BURLINGTON DEVELOPMENT REVIEW BOARD Tuesday April 18, 2017, 5:00 PM PUBLIC HEARING NOTICE

MEMORANDUM

To: Development Review Board
From: Mary O'Neil, AICP, Principal Planner
Date: April 18, 2017
RE: ZP17-0822HO; 300 Main Street #2

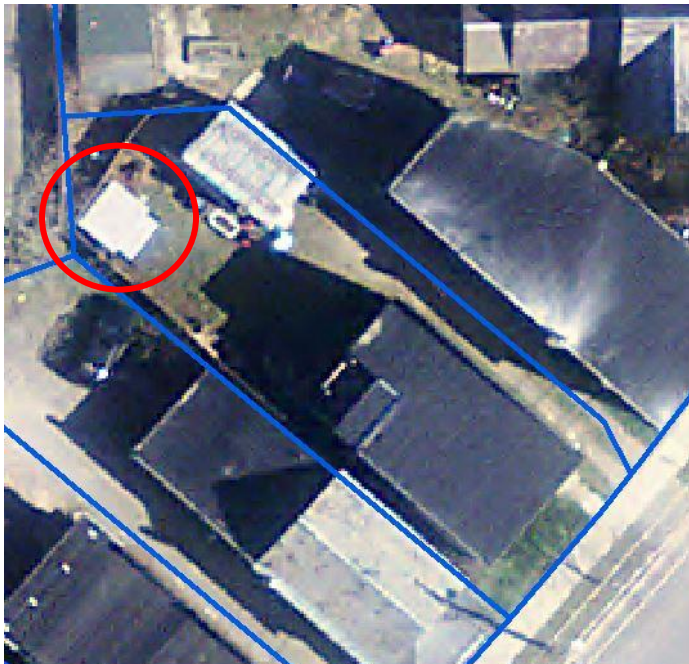
*Calculation is based on submitted information, however Google view and GIS indicate another structure on the rear/west of the lot. The applicant shall define, and include within site plan/coverage calculation.

4. The applicant shall revise the site plan/coverage calculation to include the structure visible on GIS and Google images, or remove the additional coverage from the lot to be consistent with the submitted site plan.

Photo 5 – South wall of shed. Siding is in contact with ground. Some of the siding is rotted.

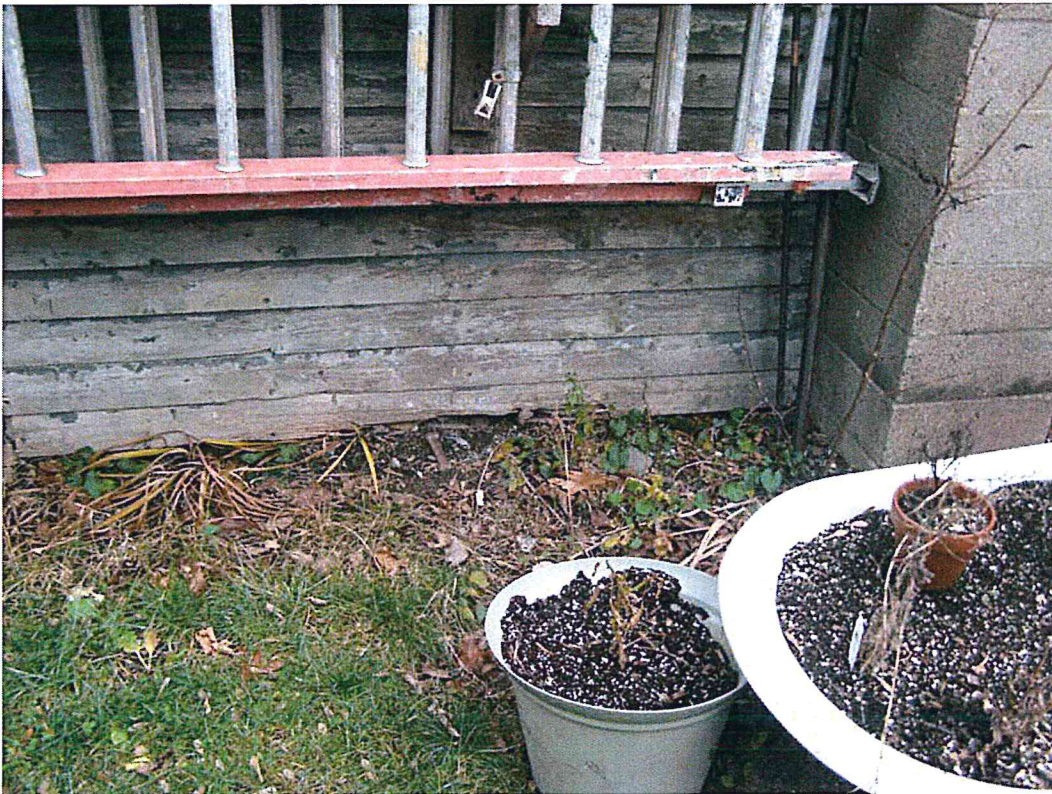
Photo 6 – South wall of shed.

Figure 3: Turning Movement Template (passenger vehicles) – Opposing Lefts

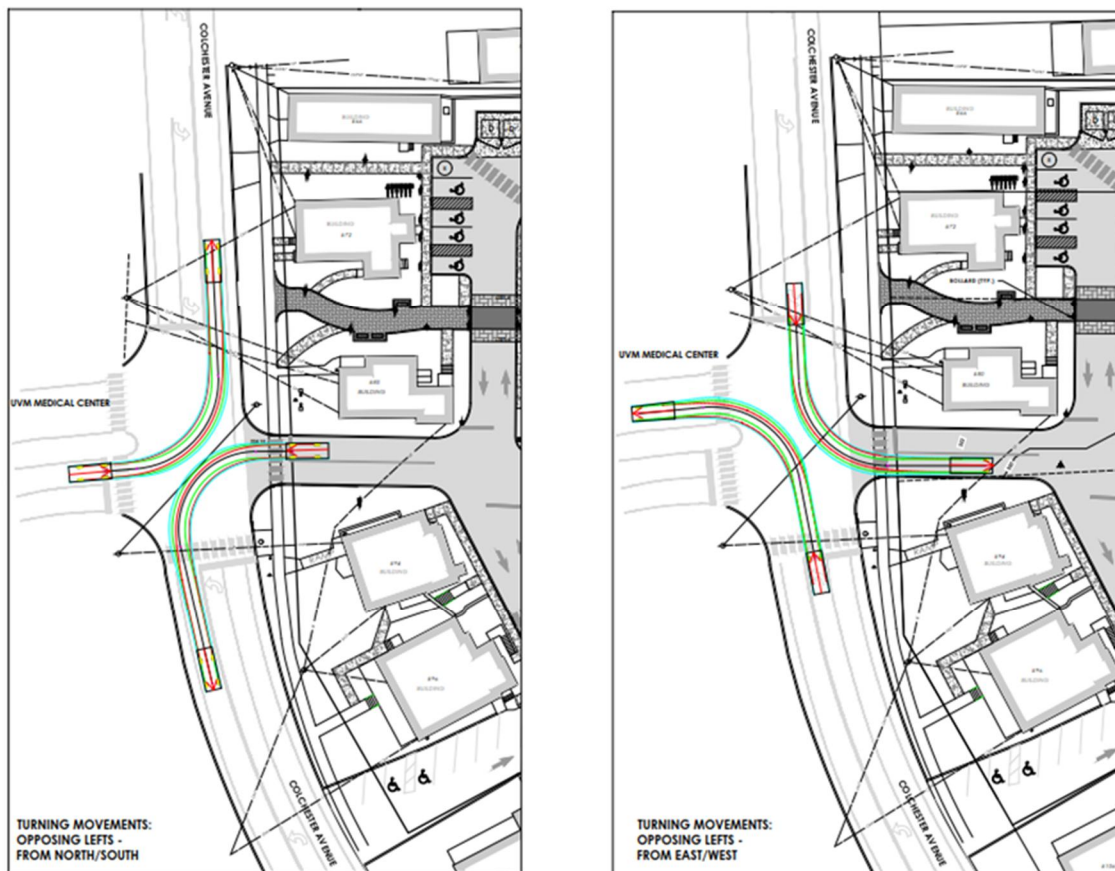
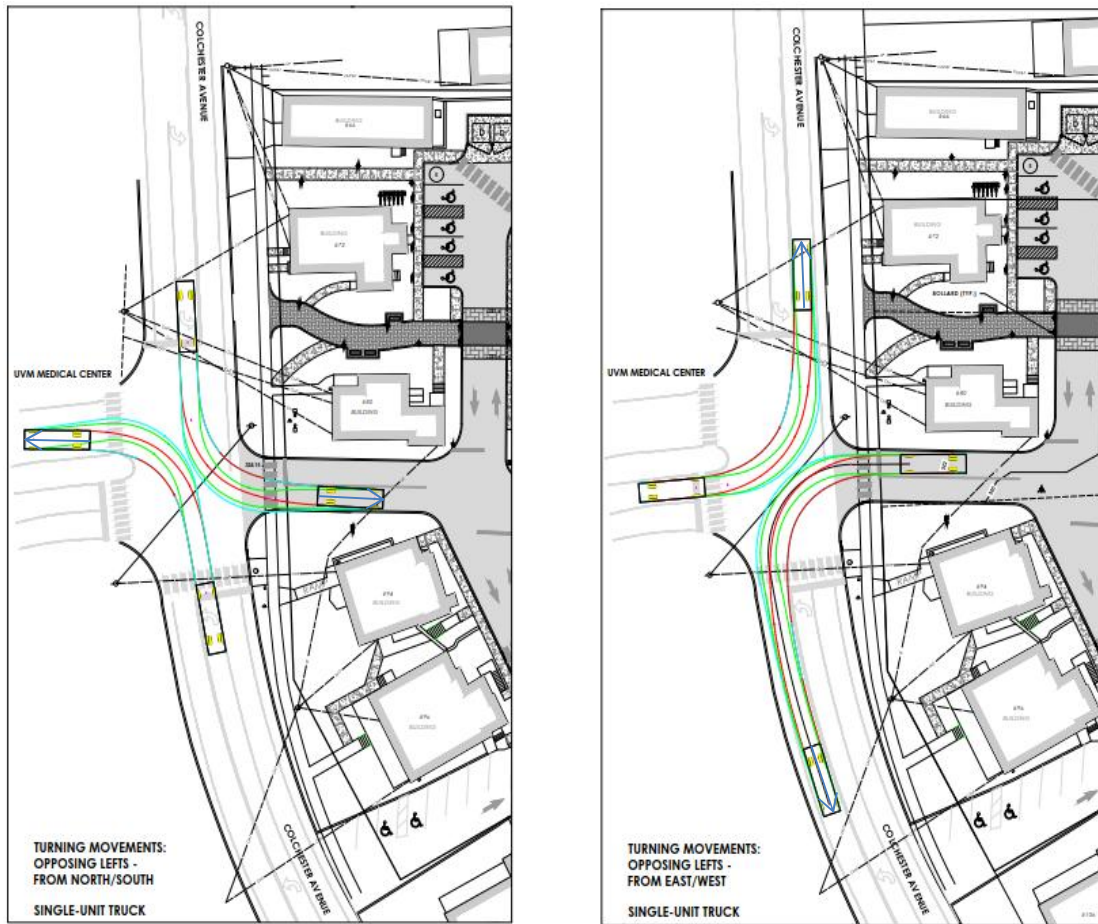
The split phase scenario on the north and south approaches was run given the off-set. The turning movement template in Figures 3 and 4 indicates that the opposing lefts are not in conflict for passenger or ambulance or delivery truck sized vehicles. Should this prove to be an issue, the corridor can accommodate this change to the phasing with no significant effect on delay or LOS.
